SERVICE LETTER / NOTIFICATION – FEB 18 2020

Subject/Purpose
Nose gear bungee upgrade to Shock Suspension System

Affected Models
Chris Heintz (CH) STOL CH750 SLSA, CH601/CH650 SLSA, CH750 Cruzer, CH750 SD.

Above photo shows a typical installation

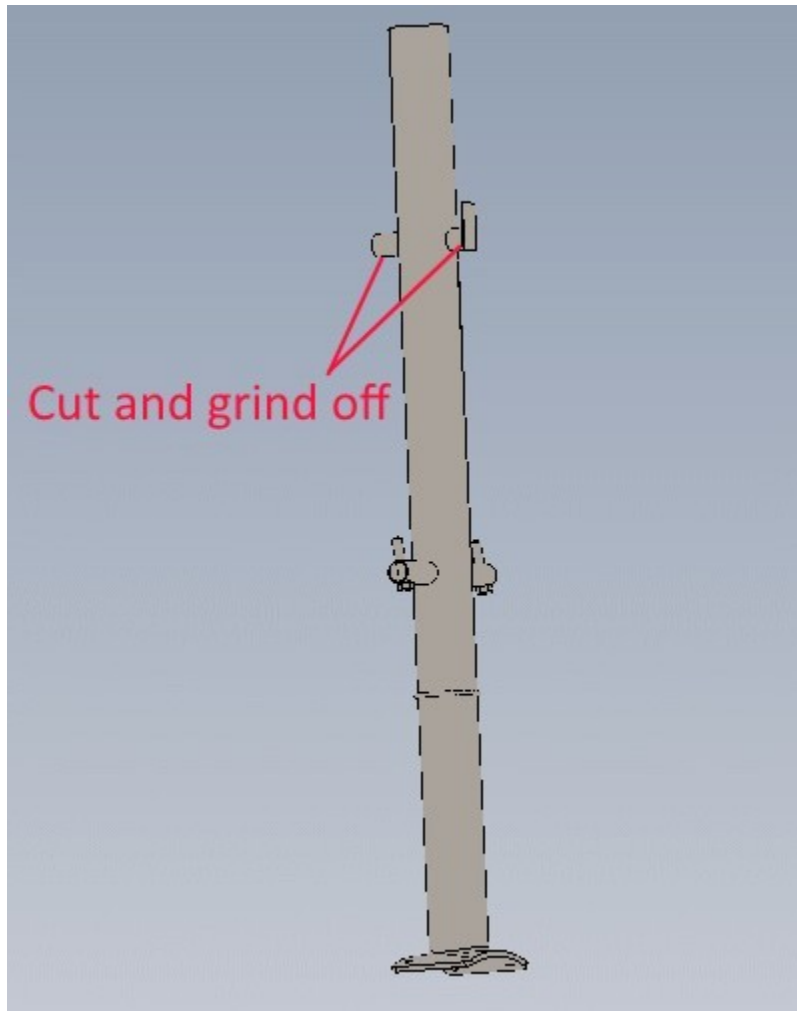
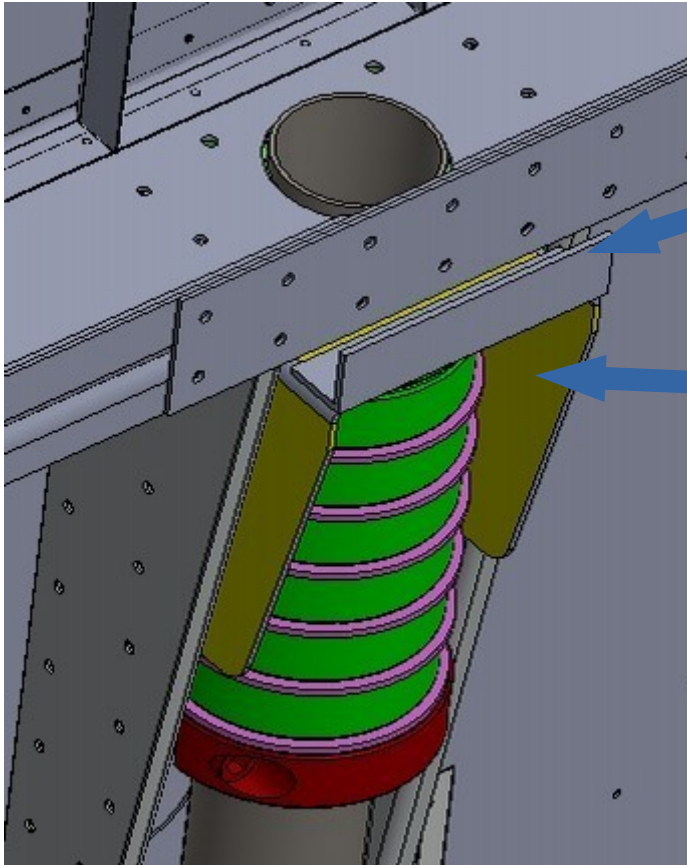
Background
The original STOL CH750 uses a bungee system for the nose gear strut. Aircraft owners have the option of upgrading to the latest nose gear Shock Suspension System design.

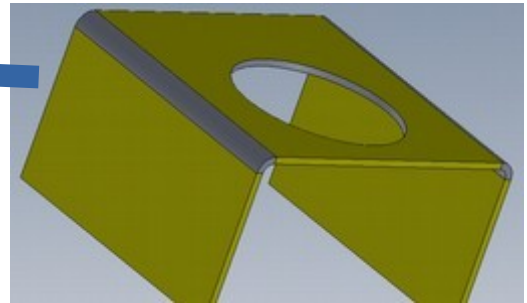
Remove the nose gear strut.
Cut off the Bungee support arms on the gear strut as shown. Grind for a smooth finish, flush with the tube.

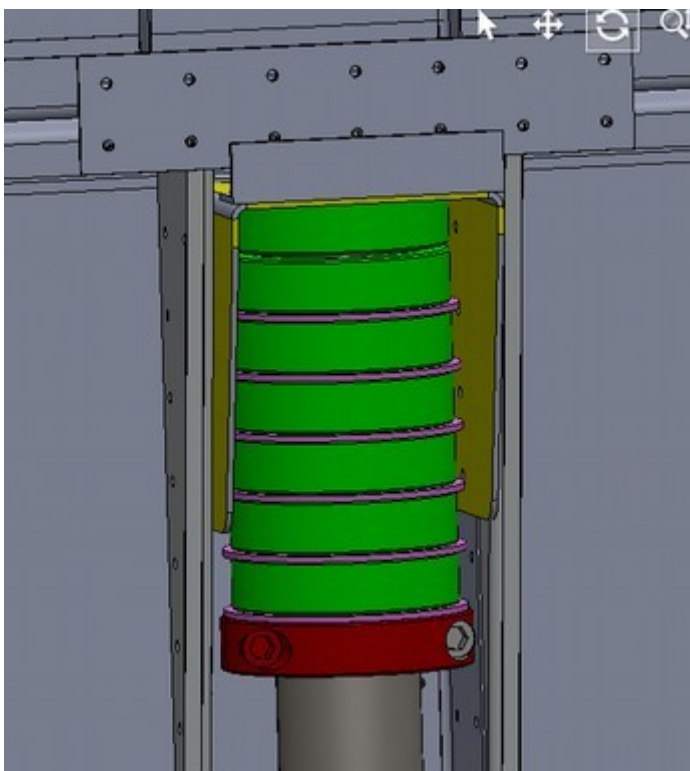
Install the Zenair supplied rubber shock disk. Add Zenair supplied washers between each.

Add Zenair supplied clamp to the bottom with washer on top.

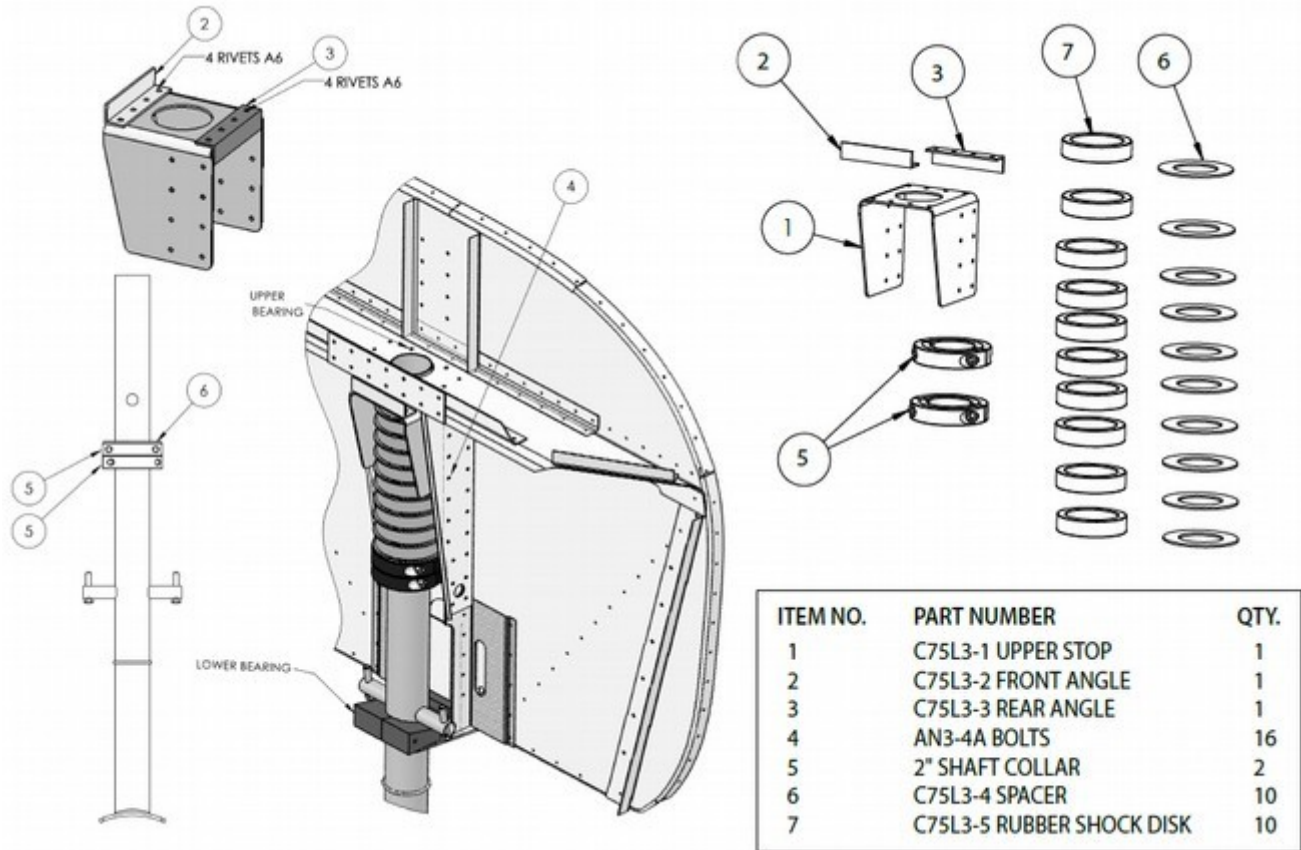
Re-install the nose gear strut.

Push up on the clamp until the nose gear self centres itself.
